**Permit #:** 61**Permit Date:** 05/02/23**Permit Type:** Planning Commission**Case Number:** PC 23-22**PC Meeting Date:** h. 1st Tuesday of October**BZA Meeting Date:****Assigned Meeting Date:** 10/03/2023**Special Meeting Date:****Applicant Is:** Contractor**Applicant Name:** ELY Mandle**Applicant Address:** PO BOX 647**Applicant City, State, ZIP:** Oxford MS 38655**Applicant Phone Number:** 731-426-3964**Applicant Email:** ely@ascentnashville.com**Description:** Proposed structurally supported parking pad constructed in the steep slope.**Project Cost:** 2000**Square Feet:** 0**Lot Area:** 0**Lot Coverage:** 0**Heat/cooled area:** 0**Proposed Height(ft.):** 0**#of stories:** 0**Lot Depth/Width Ratio:****Avg. front setback of adjacent homes:****Zoning District:** Zone C**Radnor Lake Impact Zone:** Yes**Steep Slope:** Yes**Plat/Subdivison:** No**Status:** Open**Assigned To:** Steve Mallory**Property**

## MEMORANDUM

Subject: PC Case 23-22, Radnor Lake Impact Zone and Steep Slope Site Plan for 5031 Lakeview Drive

N 63°33'25" W 167.49' (SURVEY)  
 N 67°24'00" W 167.46' (DEED)

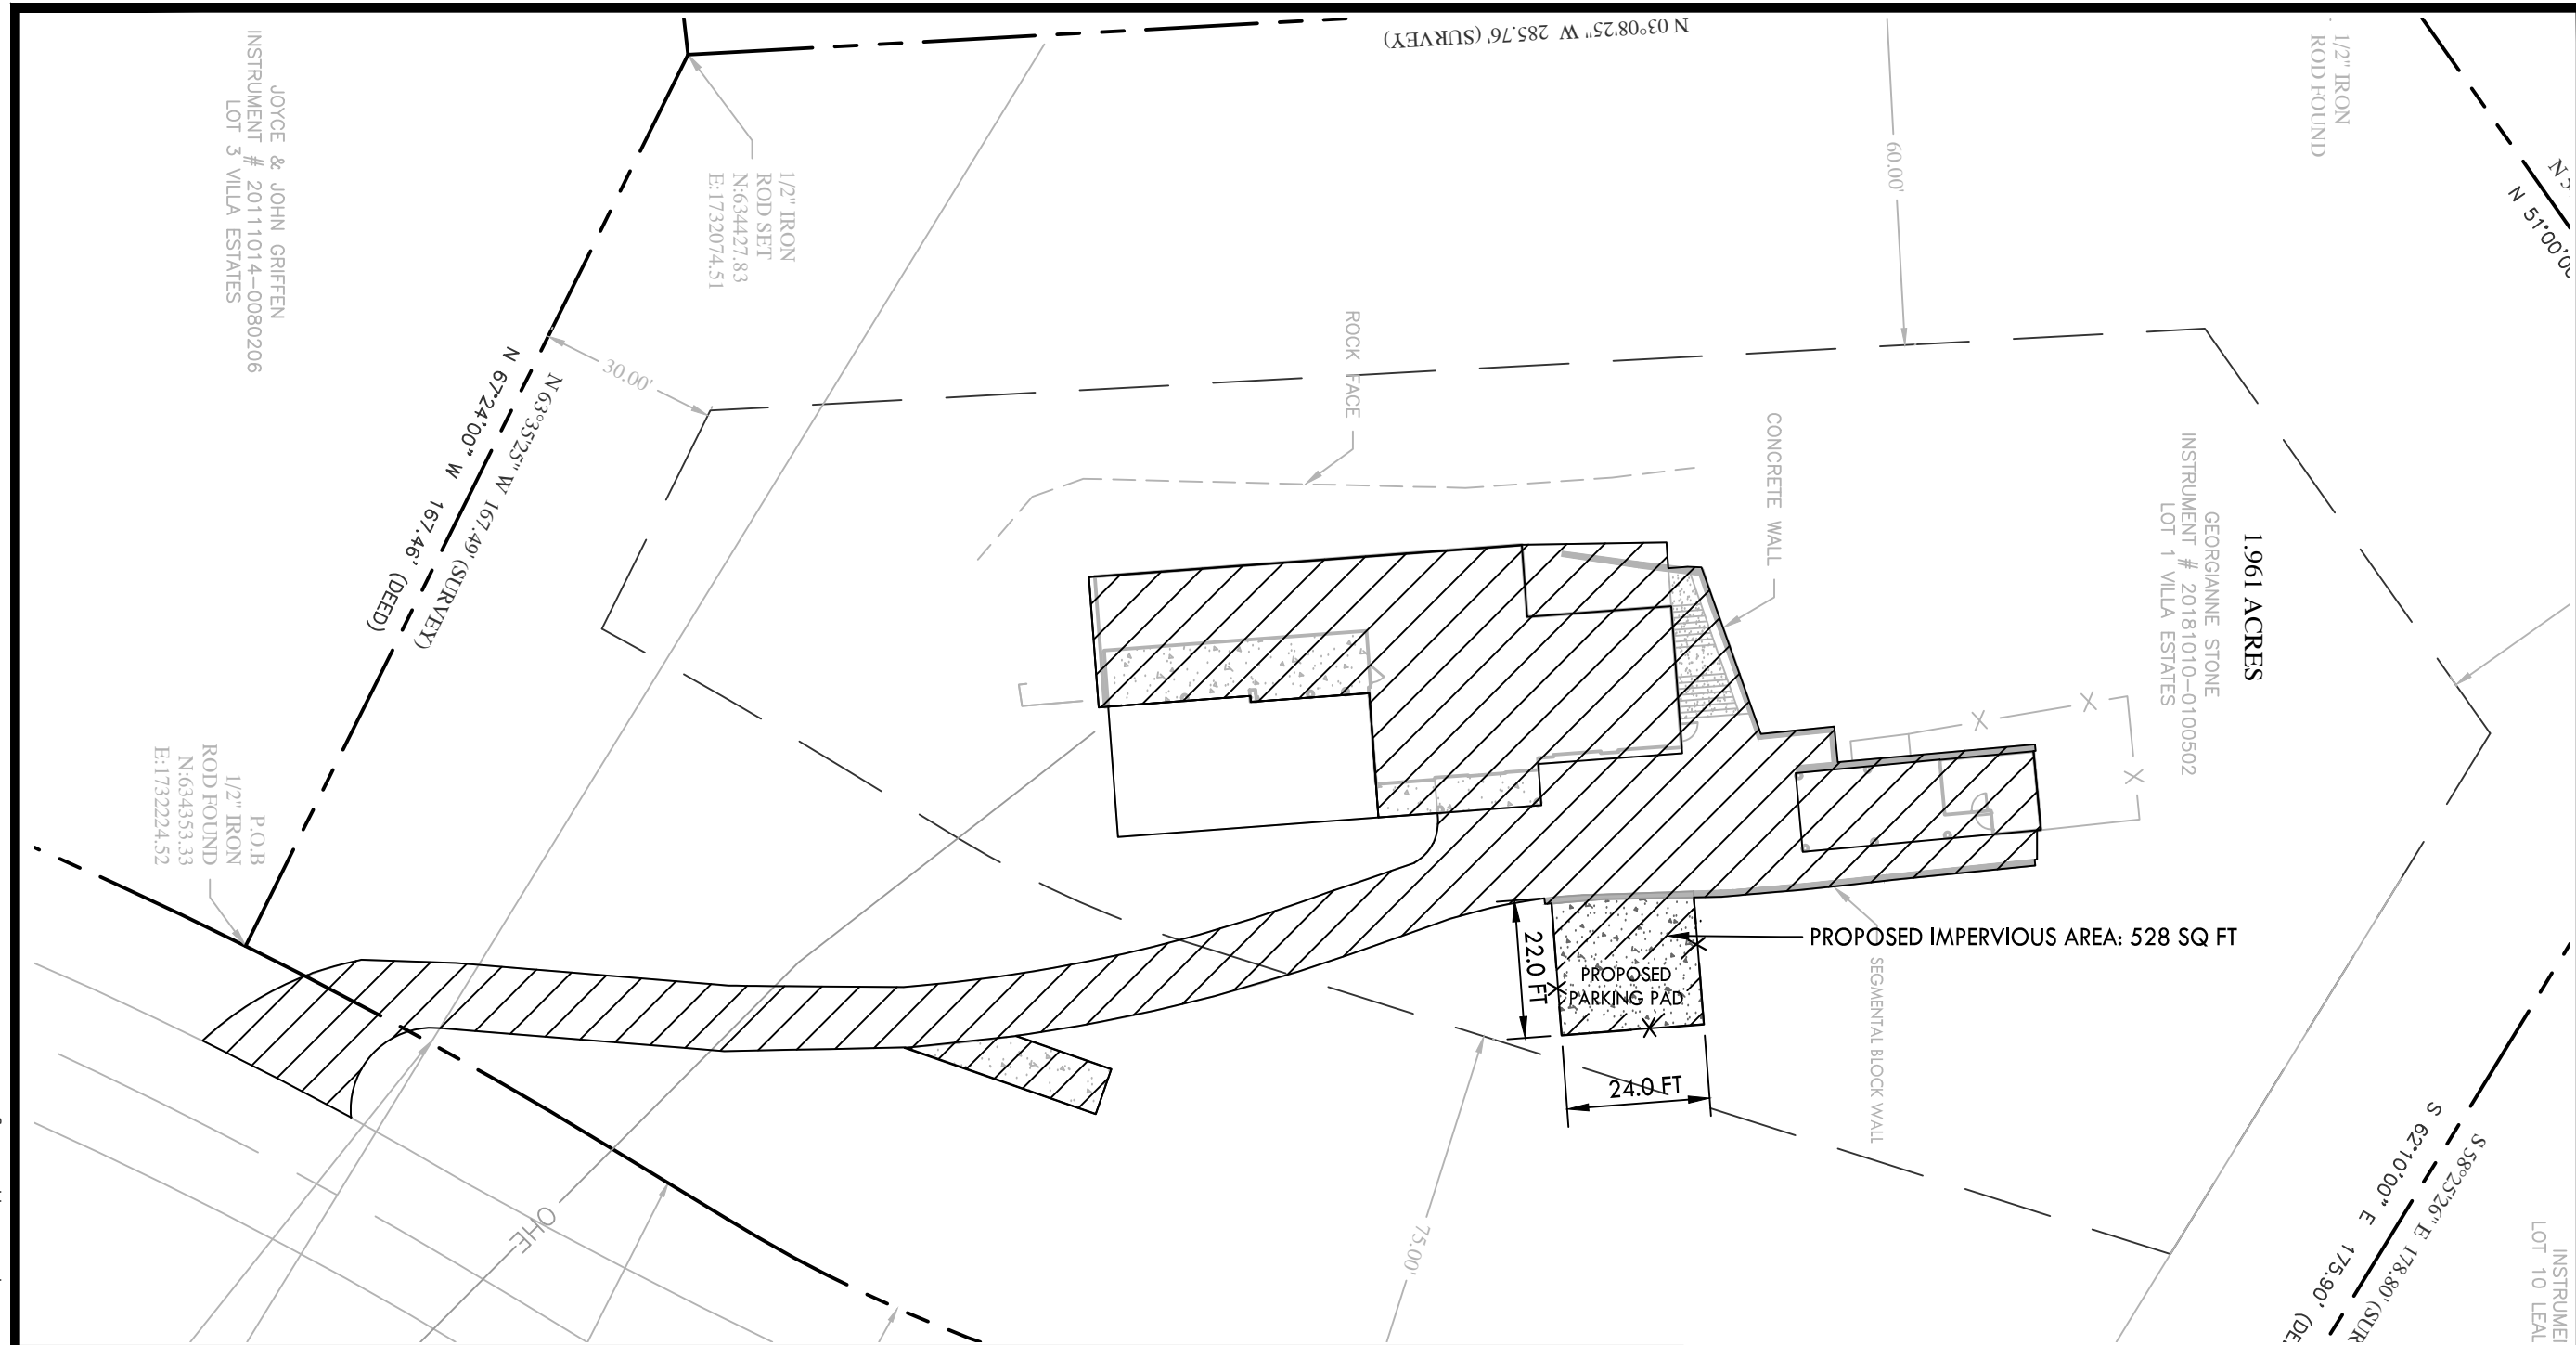
1. Show the proposed pool equipment pad on the site plan.
  - a. Provided. This has been removed as the pool was not approved for a variance at BZA.
2. Provide stormwater management for the added impervious area.

- a. Stormwater management is not required for the parking pad since it is taking the place of the concrete patio that was originally approved and permitted as impervious area with the original design. This concrete patio was not built resulting in a decrease in impervious area of 947 sf from the original approved plans. The parking pad is 528 sf. Therefore, there is still a net decrease of 419 sf of impervious area from the original approved design plans.

# WATER FLOW CHART

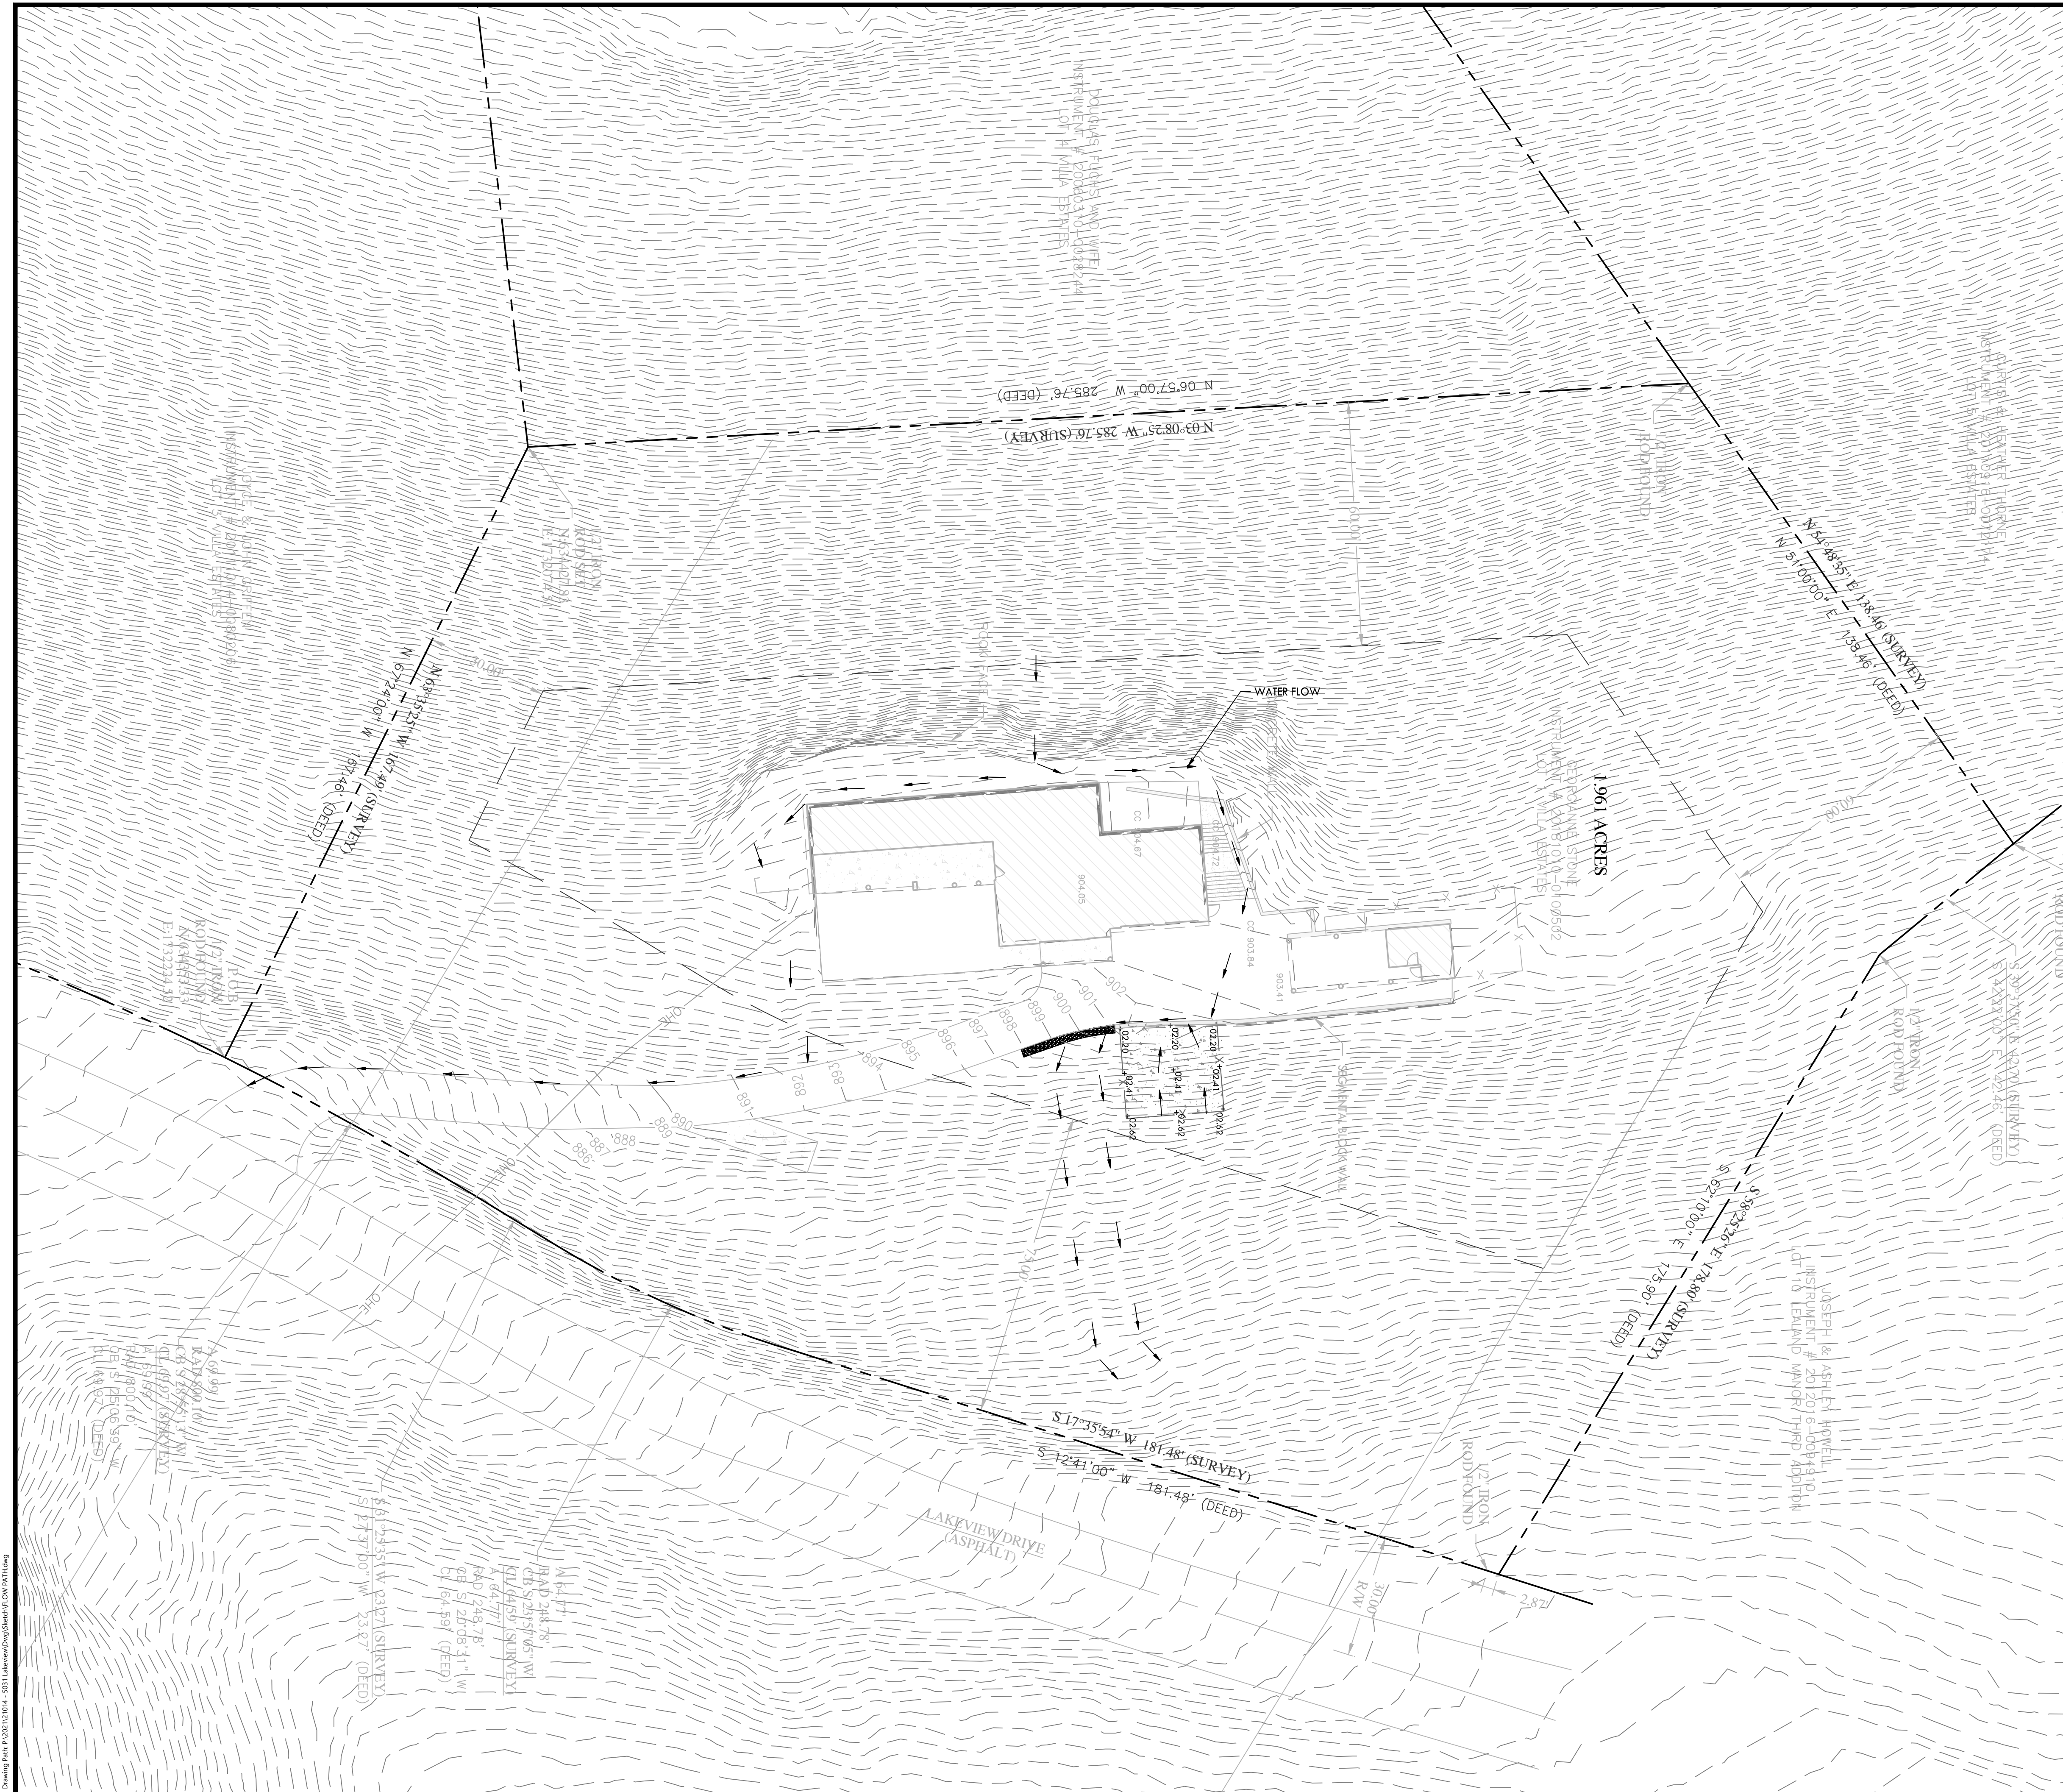
- 1. Drainage concerns going towards neighbor.
  - a. Plan has been provided to show drainage pattern from parking pad going back toward driveway, then down driveway toward Lakeview. The stone level spreader that was installed will capture water as it comes off of the driveway and any excess water that is not captured by that stone chamber will flow down the slope towards Lakeview and get into the roadside ditch along Lakeview Drive.
